Information on material change for vacuum filter dust case (filter cover)

We would like to inform you that the material of the dust case (filter cover) used in our vacuum filters VFR and VFU will be changed in order to ensure the stability of the resin material.

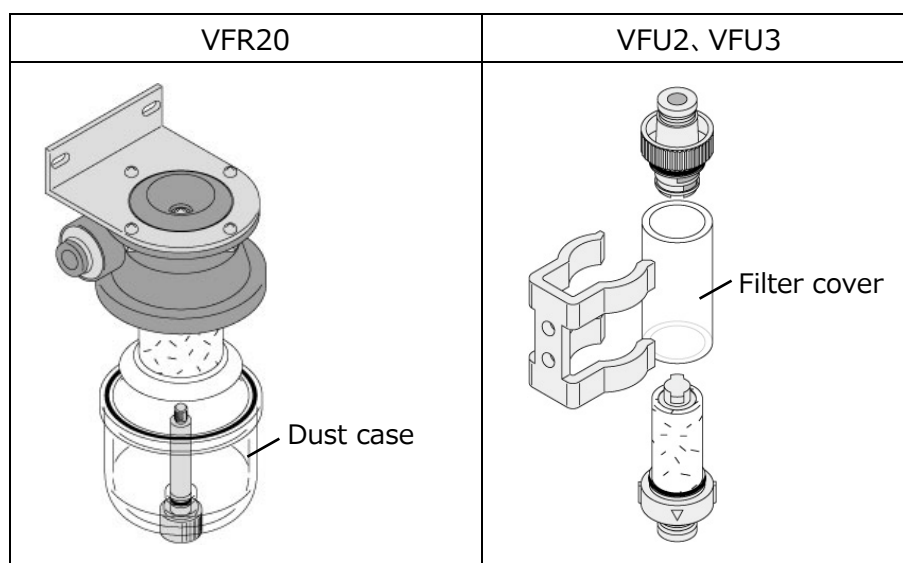
- Subject model Vacuum Filter VFR type Model code : VFR20-□
 Example) VFR20-10-10、VFR20-12
 VFU2 type Model code : VFU2-□ Example) VFU2-66P、VFU2-44P-NH
 VFU3 type Model code : VFU3-□ Example) VFU3-88P、VFU3-66P-NH

- Changes Material change of dust case (filter cover)
 Current: PCTG [Polycyclohexylene dimethylene terephthalate/glycol modified]
After change: Si-PC [siloxane copolymerized polycarbonate]
 *There is no change in price, appearance, or specifications.
 *Chemical resistance comparison data is available for reference.

- Effective date Scheduled to be changed sequentially from around July 2023
